RE: REVISIONS TO PREVIOUS APPROVAL SHRINK BUILDING TO GET
IT OUT OF SIDEYARD SETBACK (LESS 8' IN LENGTH). ALL ELSE
REMAINS SAME
FOR: MALLORY SQUARE - HARC # H11-01-625
KEY WEST HISTORIC DISTRICT

- 5 Revision to previous approval H10-01-355. Shrink new building to get it out of side yard setback (less 8 feet in length) All else remains same- **Mallory Square- Applicant William P. Horn Architect (H11-01-625)**

RE: ADD HANDICAP RAMP TO HOSPITALITY HOUSE, REPAINT EXTERIOR, NEW PAVING AND LANDSCAPING, DEMOLITION OF ALL NON-HISTORIC ADDITIONS, DECKS TO CABLE HUT STRUCTURE, ADD NEW TWO STORY RESTAURANT BUILDING
FOR: MALLORY SQUARE - HARC APPLICATION # HI0-01-355
HISTORIC DISTRICT OF KEY WEST

11. Request for demolition of non historic structures and new construction-
Mallory Square- Applicant William P. Horn Architect (H10-01-355)

Copyright © 1962 The Sanborn Library, LLC NPS
U.S. GOVERNMENT PRINTING OFFICE: 1962 O-548-000

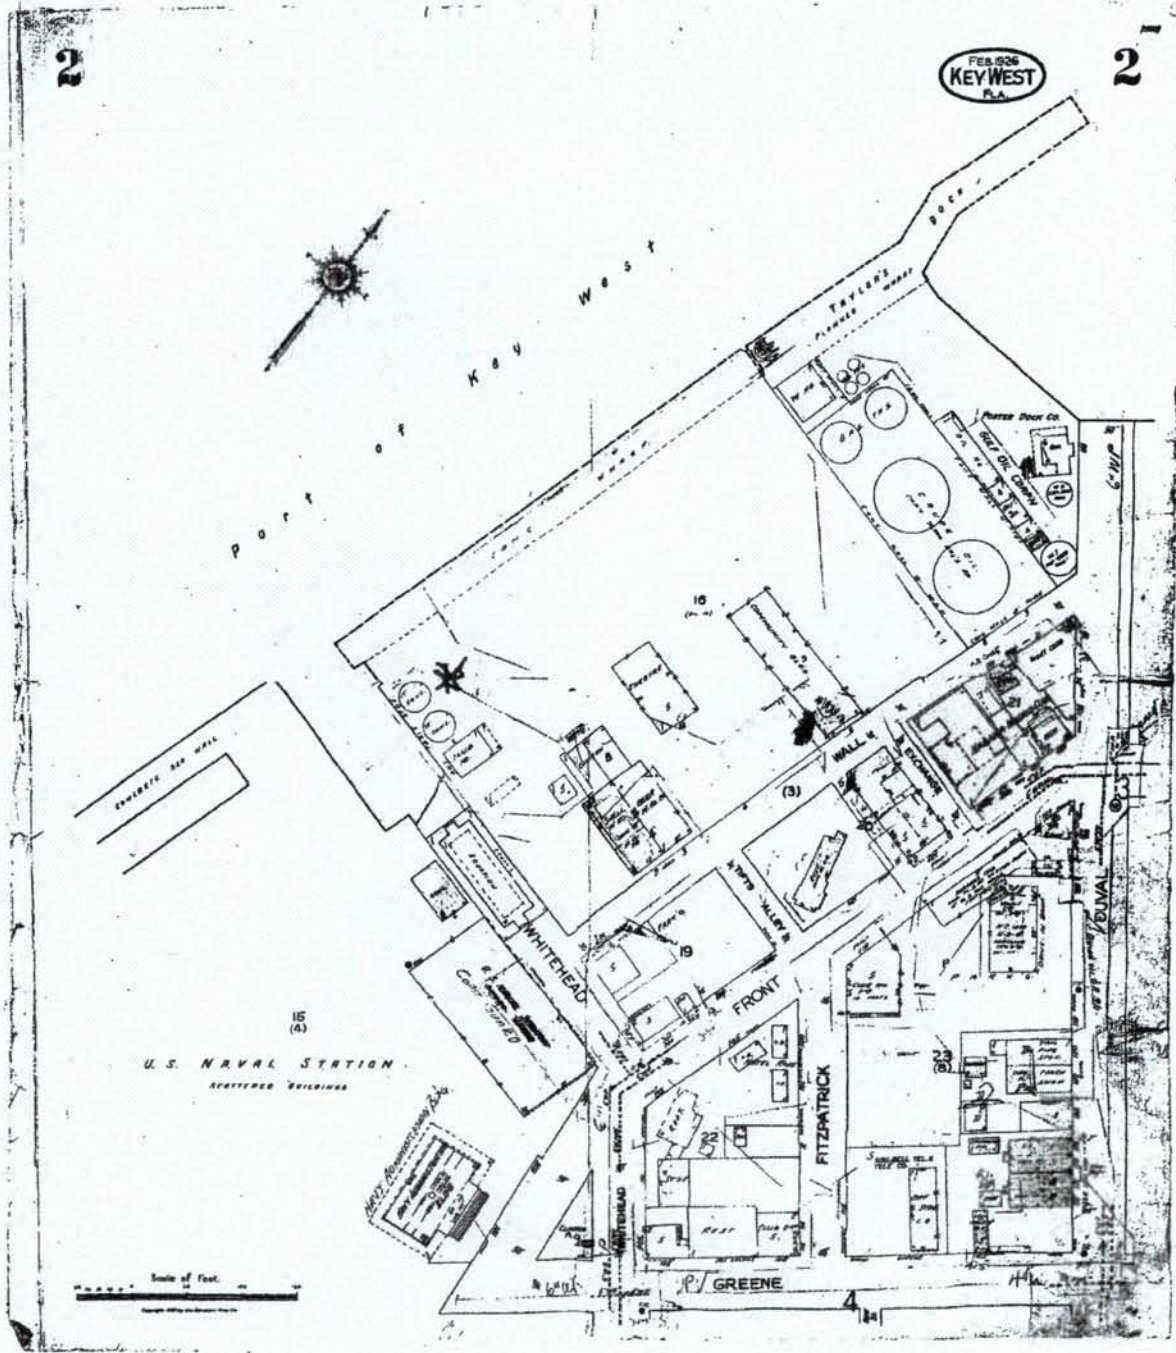
According to the Sanborn map of 1962 both concrete tanks are shown in the same location the existing ones are. The Historic Architectural Surveys of 2004, 1998 and 1976 do not include this particular structure as contributing resource; nevertheless the tank next to it, is listed as contributing.

It is staff understanding that the concrete tank that is proposed to be demolished meets the criteria of a historic structure. According to historic photos from the 1930's and 1961 and the Sanborn Map of 1962 this structure was built more than 50 years ago and is located in a historic zoning district. Staff has not found evidence that the wood frame additions or the wood deck are historic; the 1962 Sanborn Map shows both tanks with no attached additions. Staff does not have evidence that the concrete tank condition is irrevocably compromised by extreme deterioration, but an opinion from an engineer states that the structure is *Substantially Damaged*. Staff also wants to bring to the commission's attention that this structure is located within the coastal flood v zone of the FEMA map and FEMA requirements apply since the structure is not listed in the surveys as a contributing resource.
